# STAFF REPORT

## SAUSALITO HISTORIC LANDMARKS BOARD AND PLANNING COMMISSION

**Project** Plaza Vina Del Mar Accessibility Improvements  
Design Review Permit  
DR 10-029

**Meeting Date** October 3, 2012

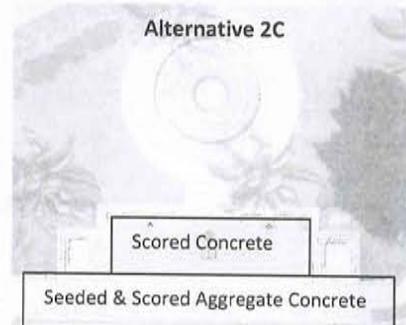
Alternative 2A as presented by the Department of Public Works is depicted to the right. The plan is similar to the project with the exception of continuing the brick-work into the side walk. The Plaza area would be demarcated by the use of brick and scored concrete and the sidewalk in front of the Plaza would be constructed out of seeded aggregate similar to the sidewalks within the general area.

Alternative 2D as shown to the right and as suggested by Planning Commissioner Werner as suggested in his letter (see **Exhibit I.13**) is similar to the project with the exception of using the seeded aggregate scored concrete from the side through the Plaza area between the two elephants.

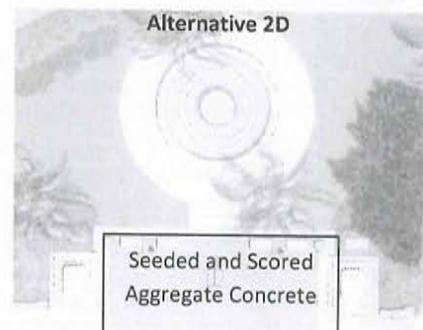
Alternative 2C as suggested by the HLB is depicted to the right. The plan replaces the brick with scored concrete to match the same color at the 5-foot wide path around the fountain. The plan would include different concrete scoring patterns between the border and the body of the area between the fountains and the sidewalk. This alternative proposes the continued use of a seeded concrete aggregate sidewalk fronting the Plaza.

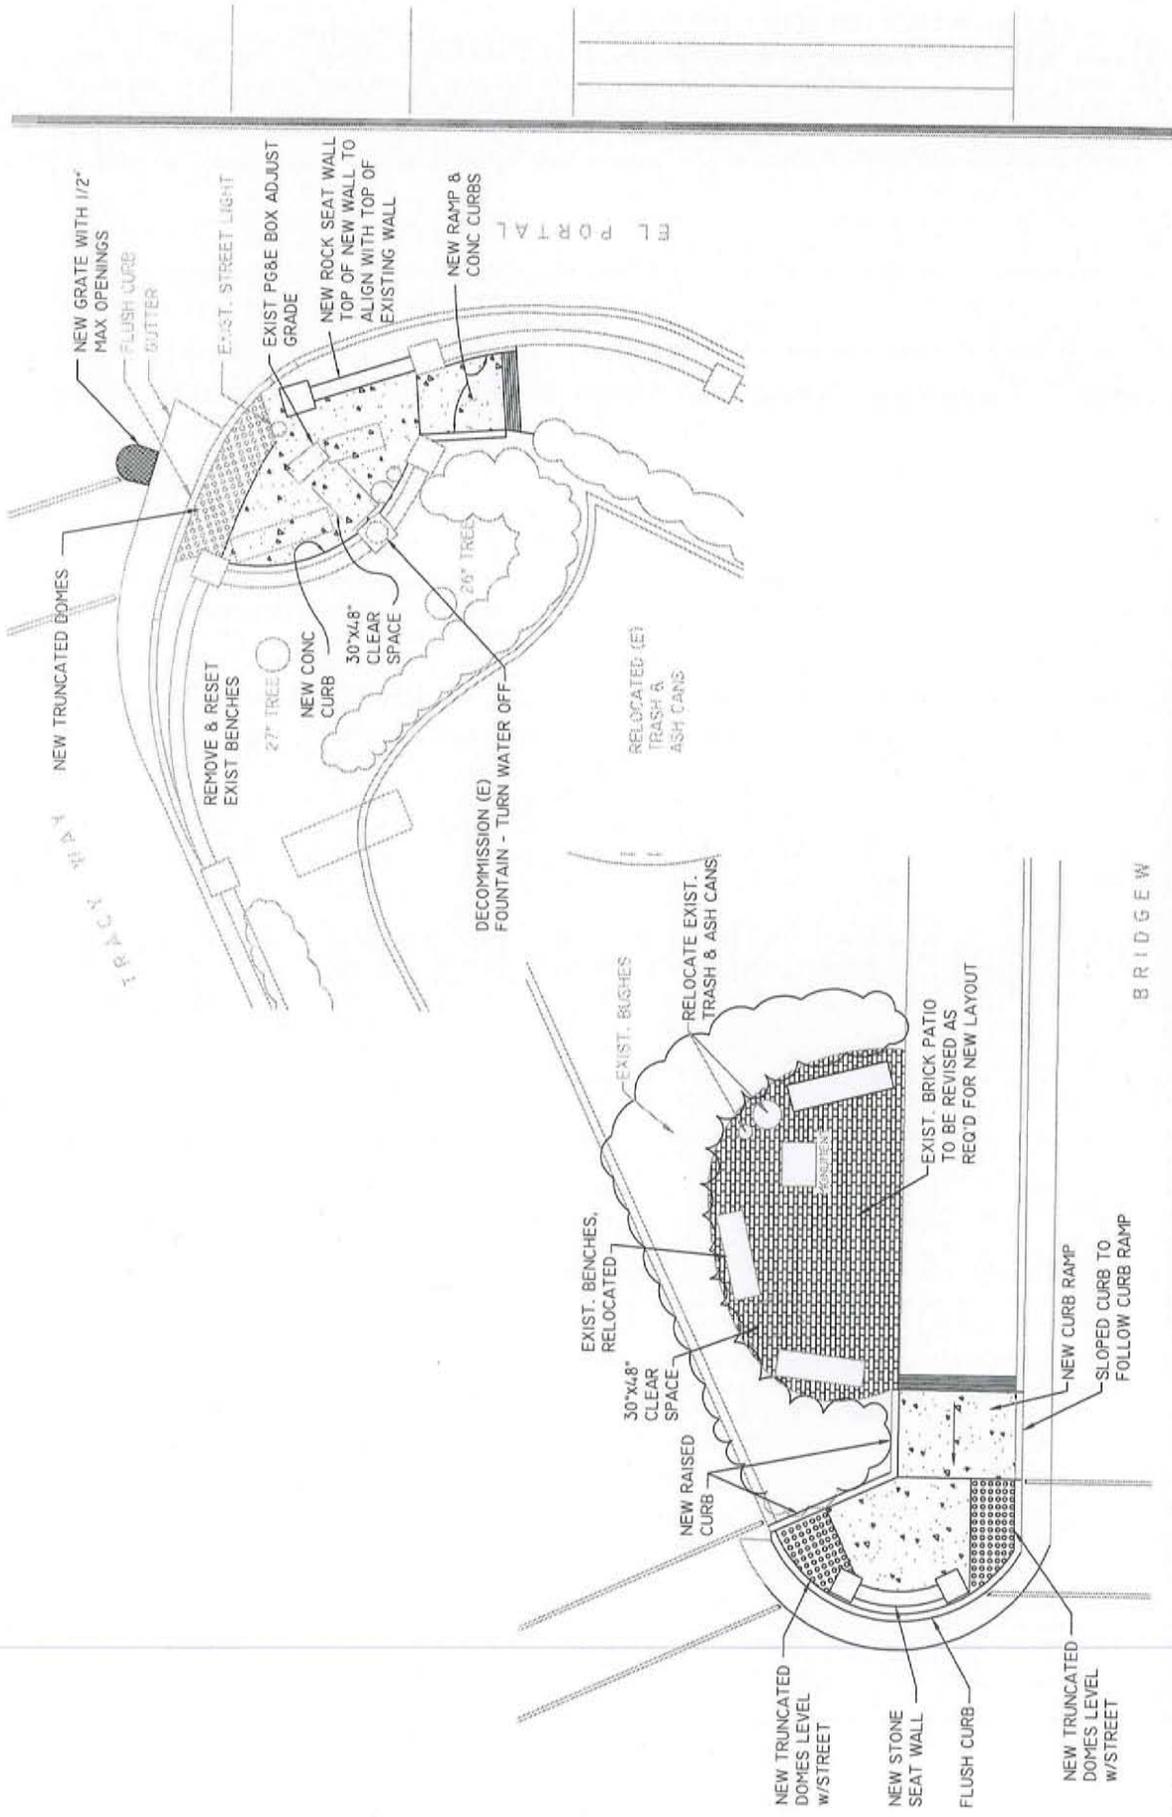
Page & Turnbull closely investigated the intersection of El Portal and Tracy Way and noted that the radially-scored concrete paving of the small plaza is designed to align with the existing historic wall piers and creates a nicely proportioned open space that would be negatively impacted by the addition of an extended wall. We suggest that the proposed wall be eliminated and that site furnishings (e.g. a planter or a trash or ash receptacle as currently exists in this location) be installed if protection for visually impaired pedestrians is desired, which is the purpose of the proposed wall as we understand it to be. Additionally, the proposed truncated domes, as currently designed, terminate at the existing streetlight. This creates an unsafe condition; the truncated domes should be reduced in area, or the streetlight (at the center of the radial composition) should be relocated.

Furthermore, the plaza area at the intersection of El Portal and Tracy Way will be reconstructed to be six to eight inches lower than the existing plaza, in order to satisfy ADA requirements. A curb will be added in front of the curved stone wall that separates the plaza from the park, which will fill the gap between the wall and the lowered grade. Page & Turnbull advises that the curb be as flush as possible to the wall, and that the new paving be scored to match the original paving. The area should be photo-documented prior to construction as an archival record, since historic fabric will be altered for reasons relating to code compliance. We also caution that mature tree root systems may be impacted by the lowered grade of the new paving; an arborist should be consulted in this regard.
